Addendum 147 – UN Regulation No. 148

Amendment 2

Supplement 2 to the original version of the Regulation – Date of entry into force: 25 September 2020

Uniform provisions concerning the approval of light-signalling devices (lamps) for power-driven vehicles and their trailers

"Figure A3-I:
Standard light distribution for front and rear position-, parking-, end-outline marker-, stop- and direction indicator lamps

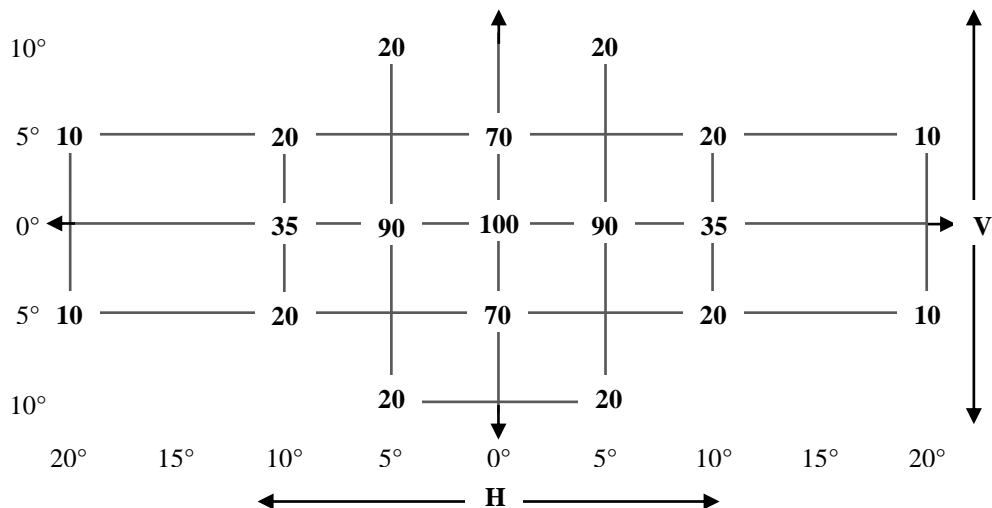
Paragraph 2.1., figure A3-I, amend to read:

Figure A3-X
Measuring points for plate size 520 x 120 mm

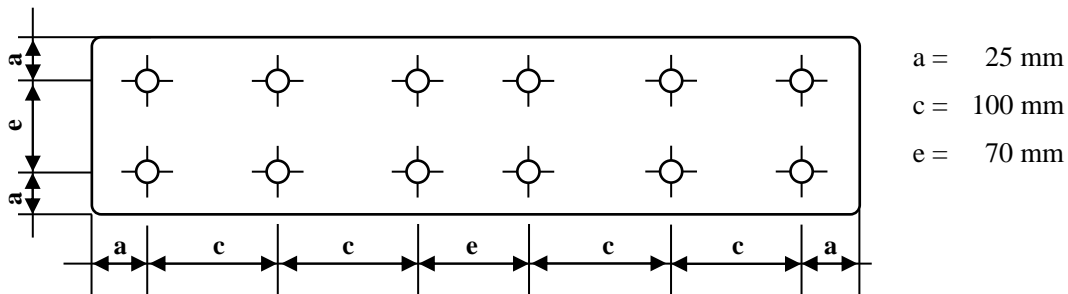
Paragraph 3.2., figure A3-X, amend to read:

"3.2. Category 1b - wide plate (520 x 120 mm)
